# Camden Lock Village / Hawley Wharf

R016 - Area D Non Material Amendment Application

## 4.0 Area D

### 4.2 Proposed Scheme

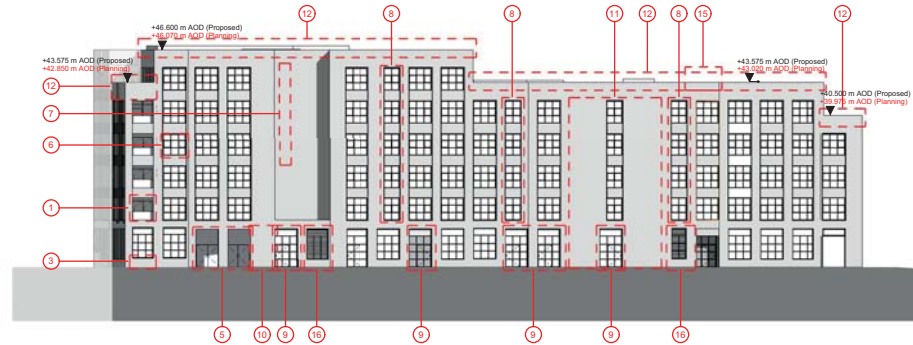
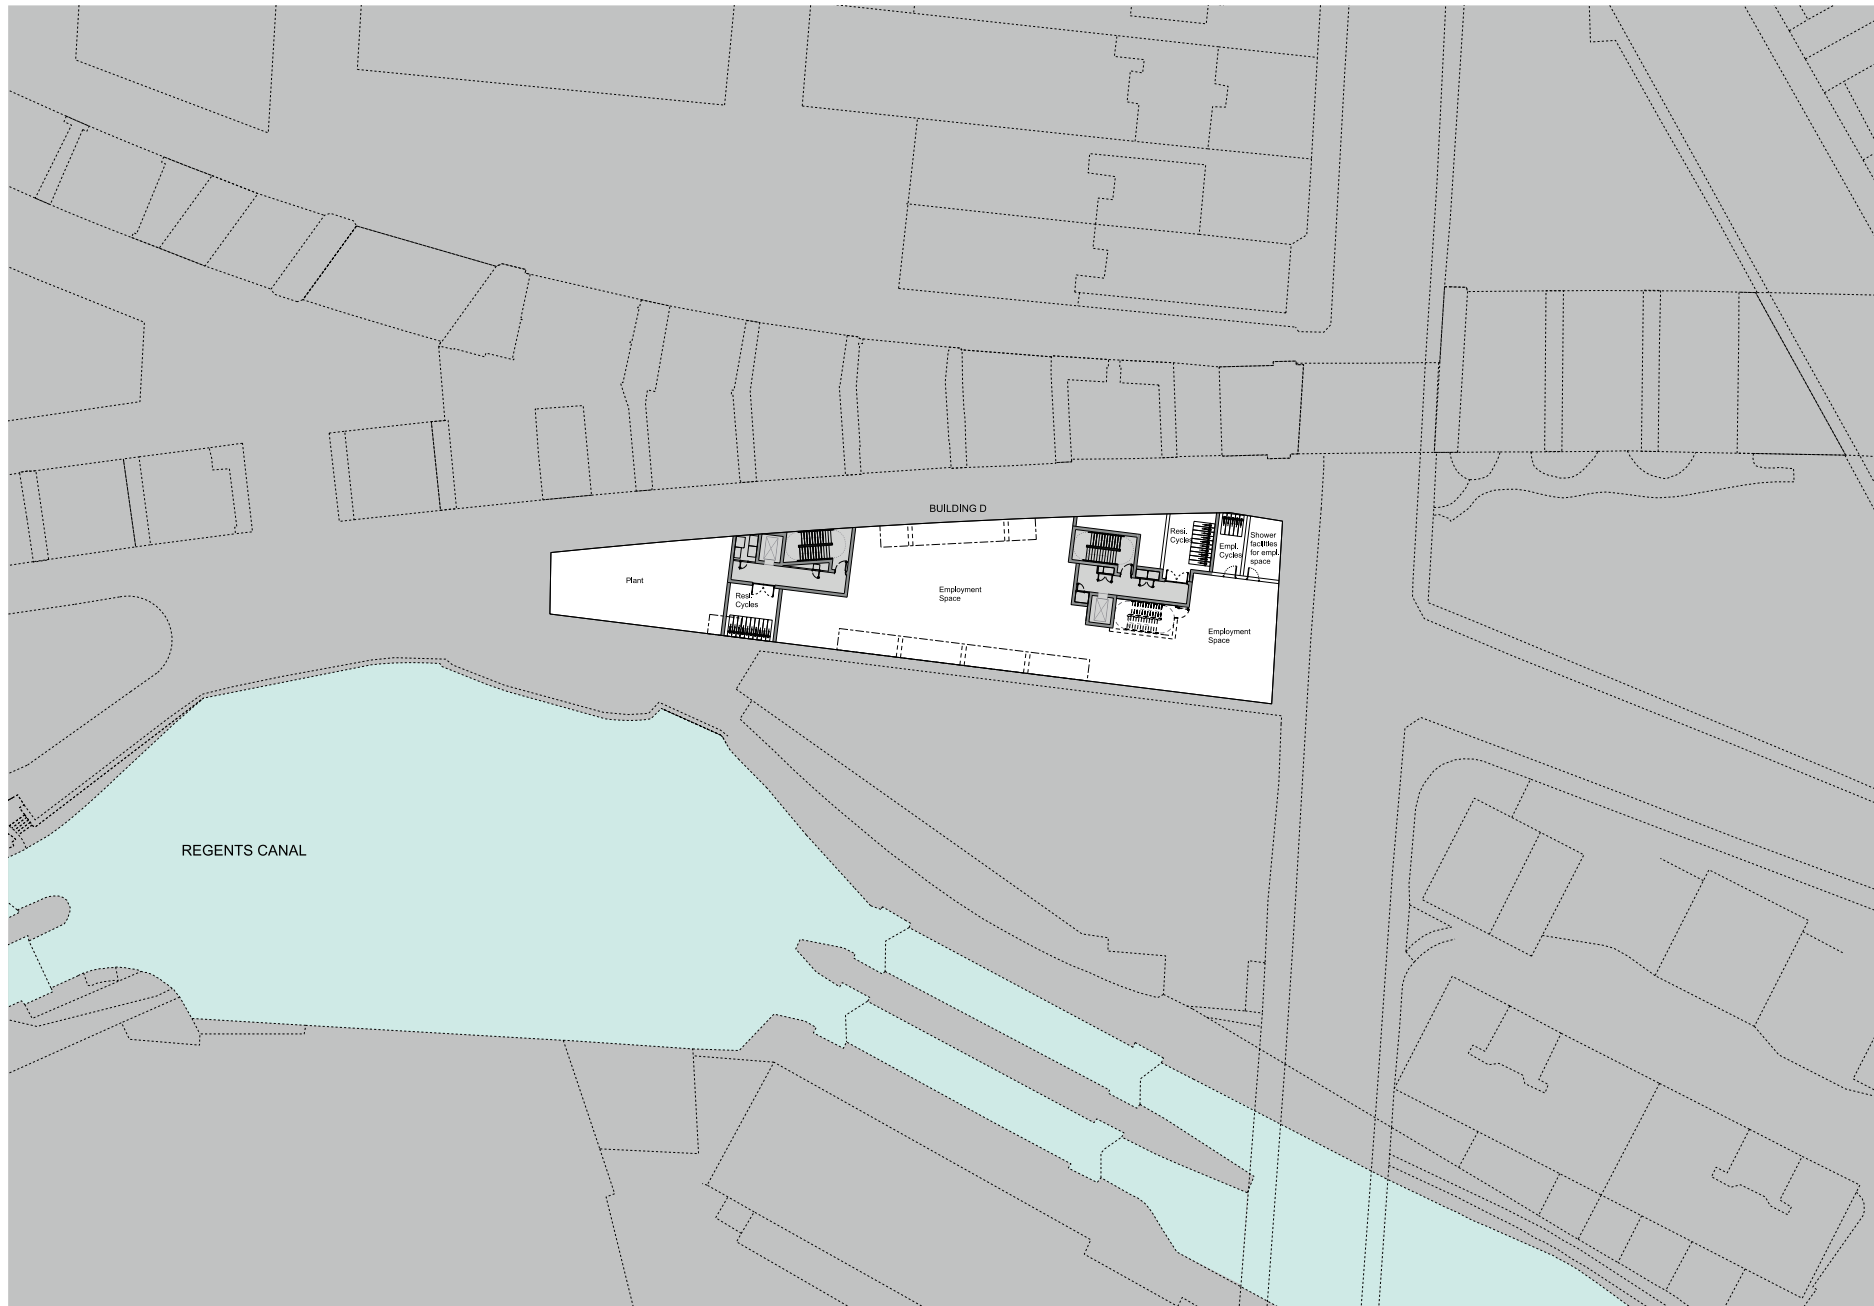
- 1 Metal railings replaced with glazed balustrades
- 2 Doors changed to fixed glazing due to revised internal layouts
- 3 Brick infills added under windows to provide protection at ground floor level

- 4 Cut back balcony introduced to break up massing
- 5 Residential entrance relocated from Kentish Town Road to Water Lane
- 6 Textured panels replaced with glazing

- 7 Windows removed from stairwell
- 8 Window size reduced to suit layouts
- 9 New doors added for escape from employment spaces in line with fire strategy

- 10 Door filled in with brickwork as no longer required
- 11 Brick infills removed and window added to staircore
- 12 Parapet heights increased to align with building E heights (see elevations for height changes)

- 13 Balcony replaced with window to allow balconies to stack
- 14 Balcony and window mirrored to align with internal layout
- 15 New flue for cafe kitchen extract

- 16 Louvres incorporated for M+E plant requirements

### 4.4 Proposed Scheme - Basement Plan

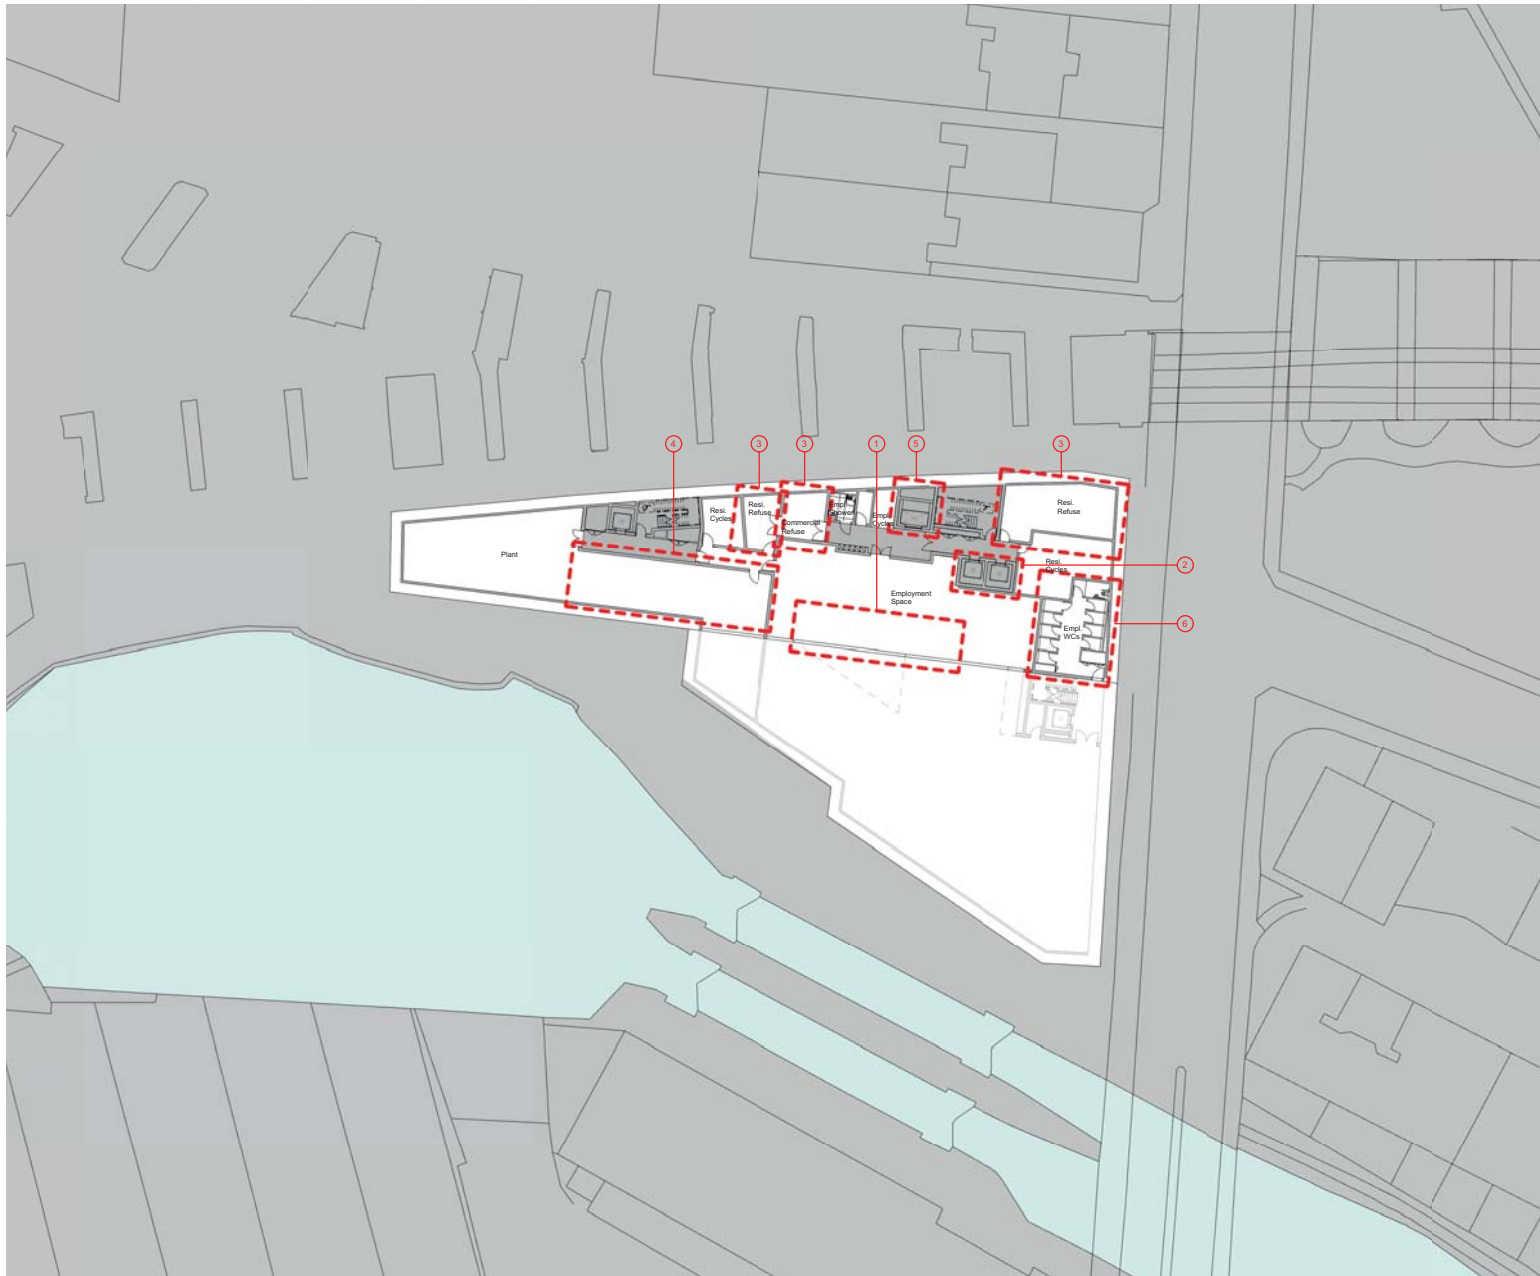
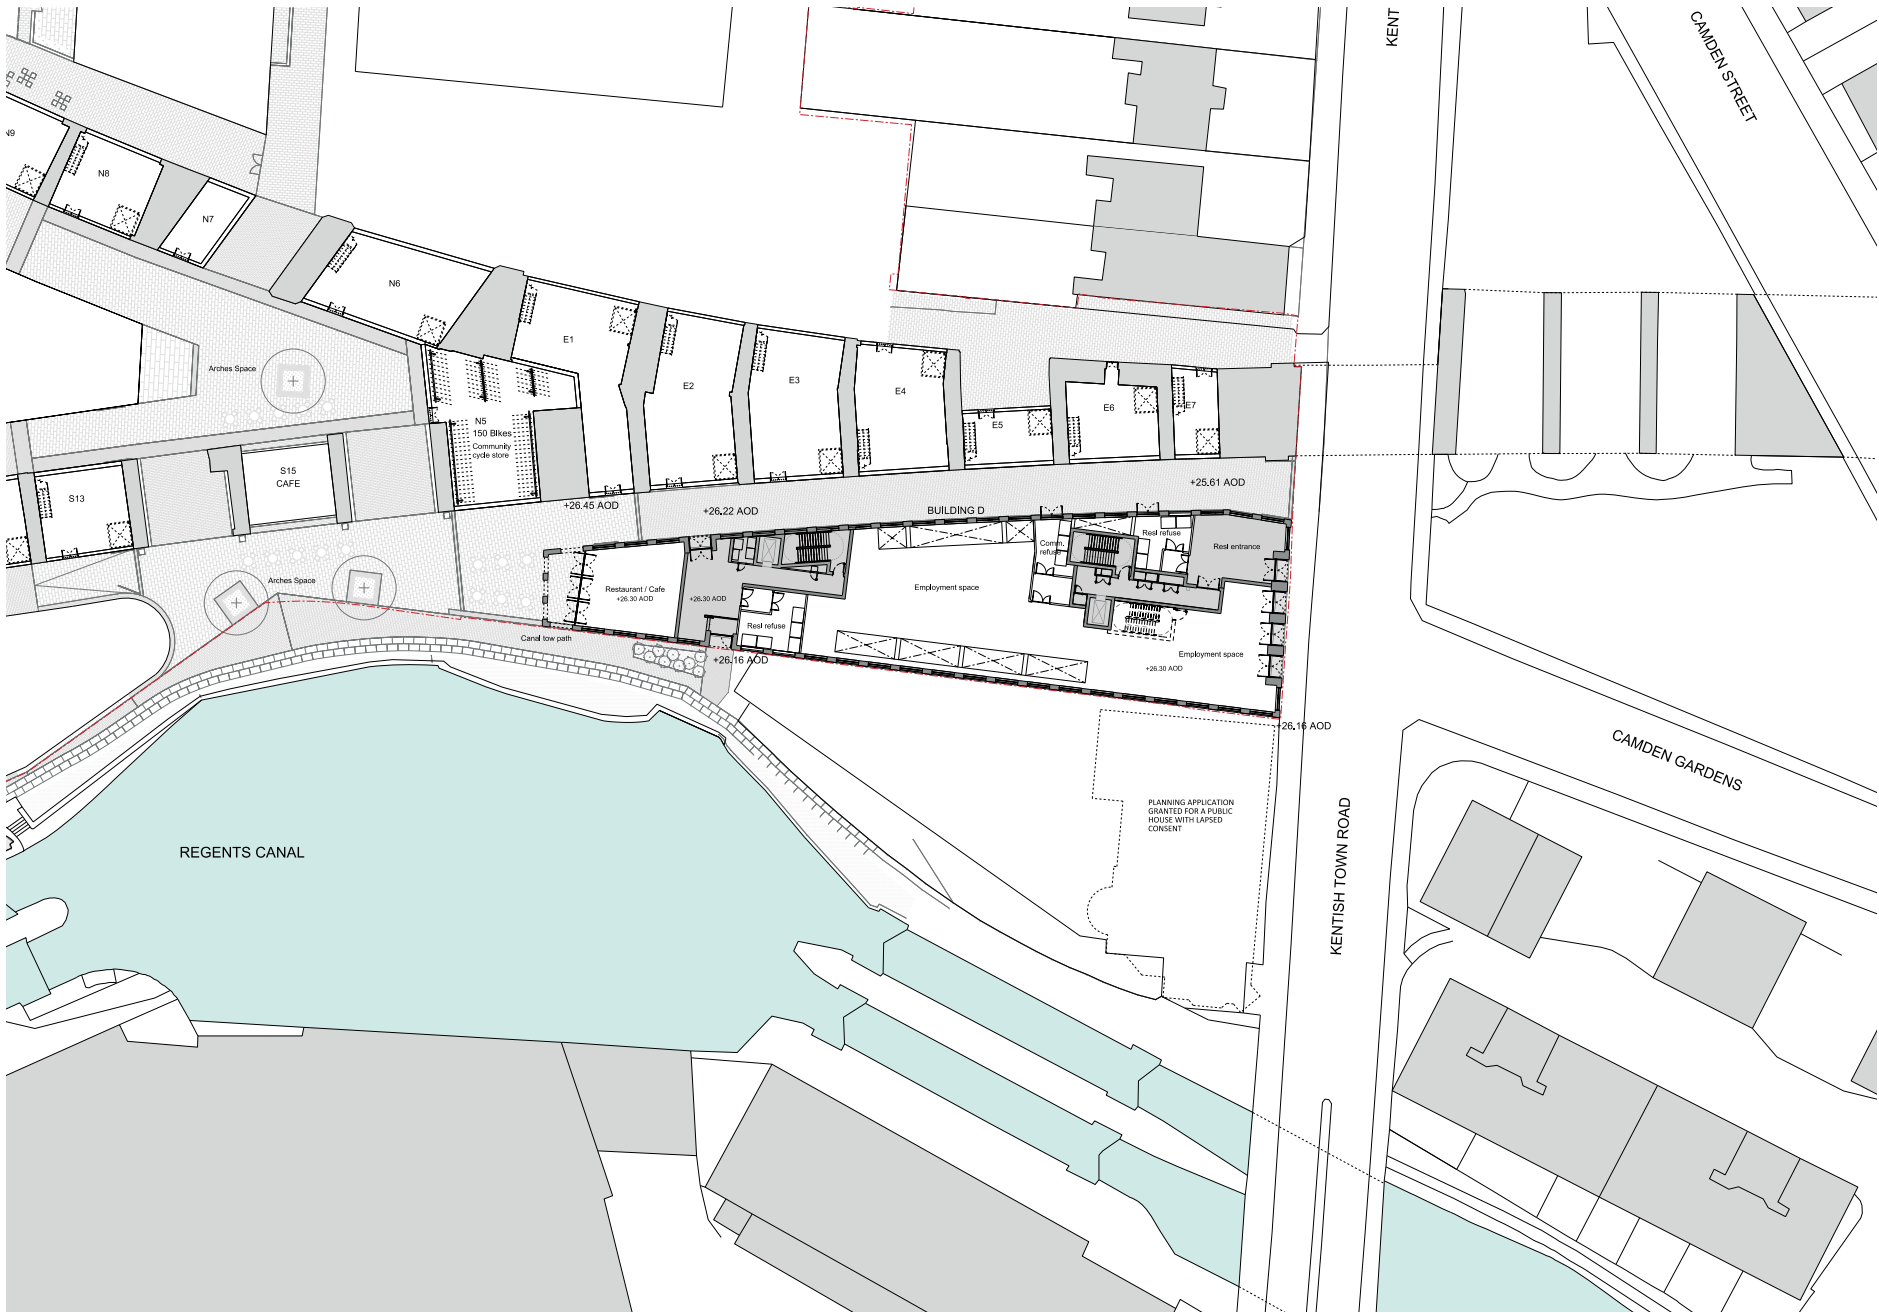
- ① Void in floor slab relocated to Area E
- ② Liftcore increased to accommodate Area E
- ③ Refuse space relocated to basement to free up ground floor accommodation
- ④ Plant space increased in line with M+E requirements
- ⑤ Goods lift added in line with waste disposal strategy
- ⑥ WCs added

- Structure added to plans

### 4.6 Proposed Scheme - Ground Floor Plan

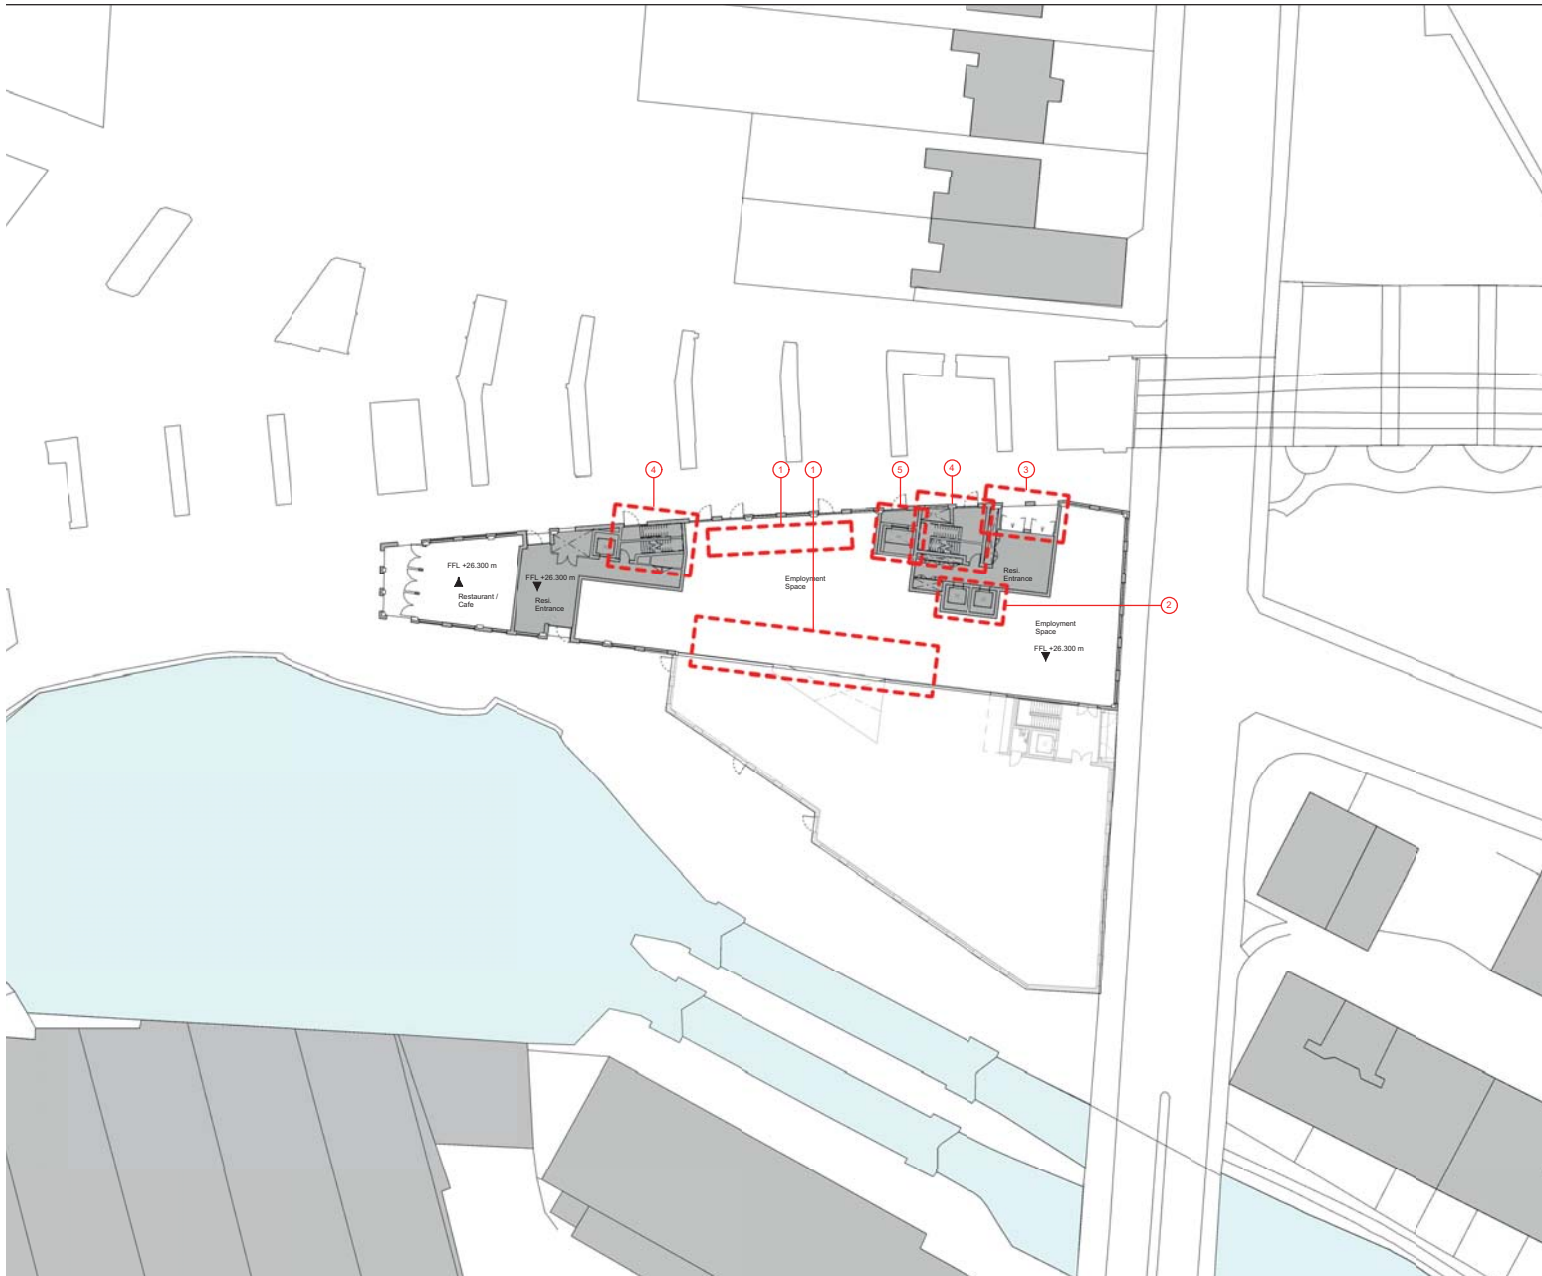
- ① Void in floor slab relocated to Area E
- ② Liftcore increased to accommodate Area E
- ③ Residential entrance relocated from Kentish Town Road
- ④ Stair reconfigured to meet fire strategy
- ⑤ Goods lift added in line with waste disposal strategy

- Structure added to plans
